Docket Item #11B
Development Site Plan #2010-0023
Yates Corner – 515 Mount Vernon Avenue, 401 and 405 East Braddock Road

Staff Recommendation: APPROVAL WITH CONDITIONS
Staff Reviewers: Gary Wagner, RLA, Principal Planner James Roberts, Urban Planner

DSP#2010-0023

Exhibit 01: Pedestrian Safety Improvements on E. Braddock Rd.

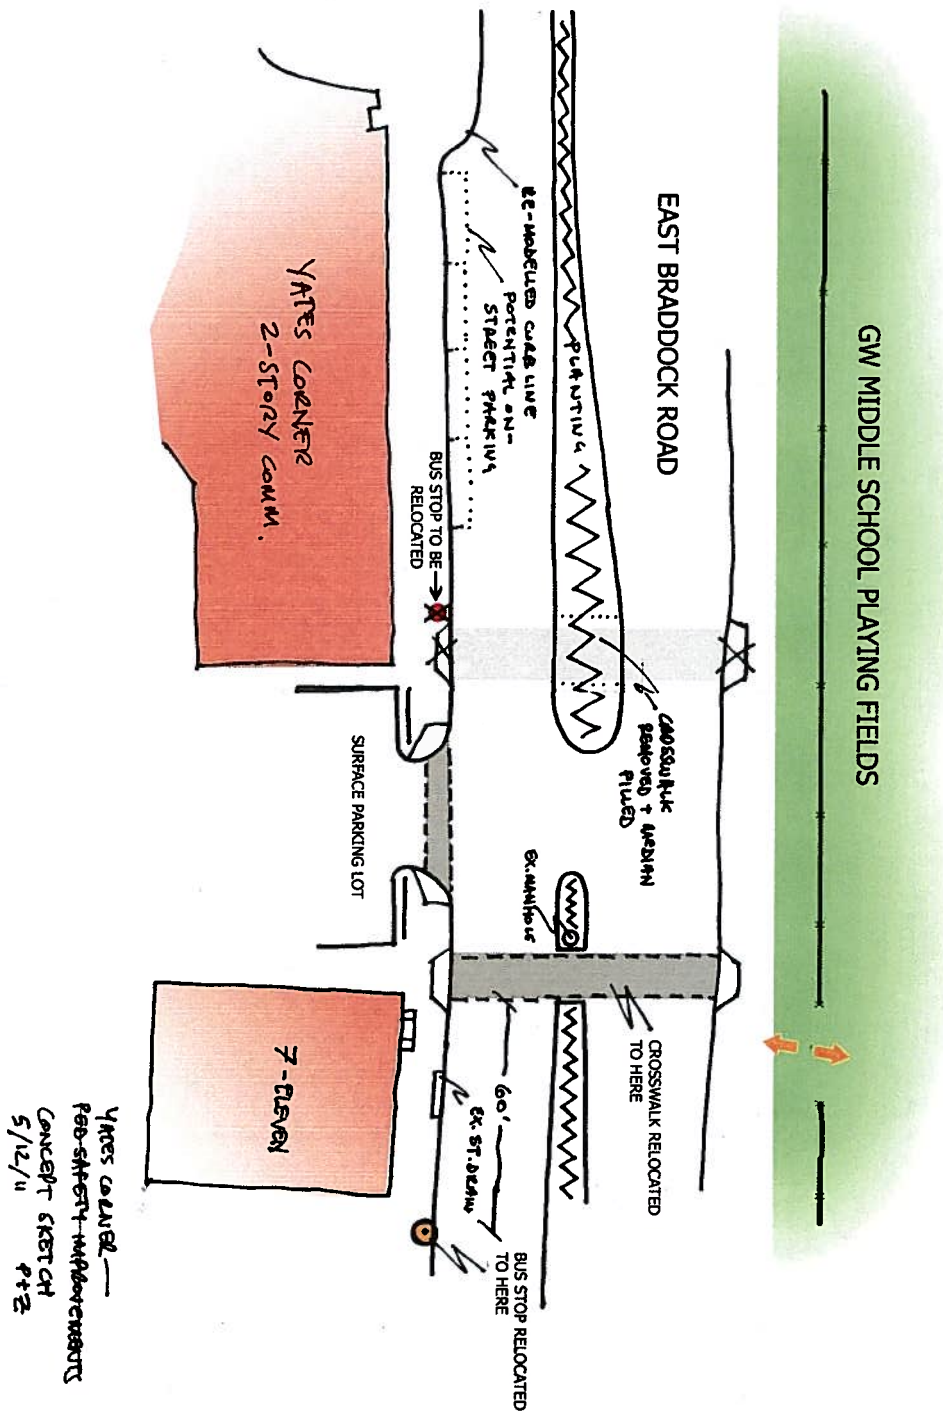
2. Provide the following pedestrian improvements to the satisfaction of the Directors of P&Z and T&ES:
 - a. Complete all pedestrian improvements prior to the issuance of a certificate of occupancy permit.

- d. All newly constructed curb ramps in Alexandria shall be concrete with detectable warning and shall conform to current VDOT standards
 - e. Provide thermoplastic pedestrian crosswalks at all crossings at the proposed development, which must be designed to the satisfaction of the Director of T&ES.

- f. All crosswalks shall be standard, 6" wide, white thermoplastic parallel lines with reflective material, with 10' in width between interior lines. High-visibility crosswalks (white, thermoplastic ladder crosswalks as shown in the Manual on Uniform Traffic Control Devices (MUTCD)) may be required as directed by staff at Final Site Plan. All other crosswalk treatments must be approved by the Director of T&ES.
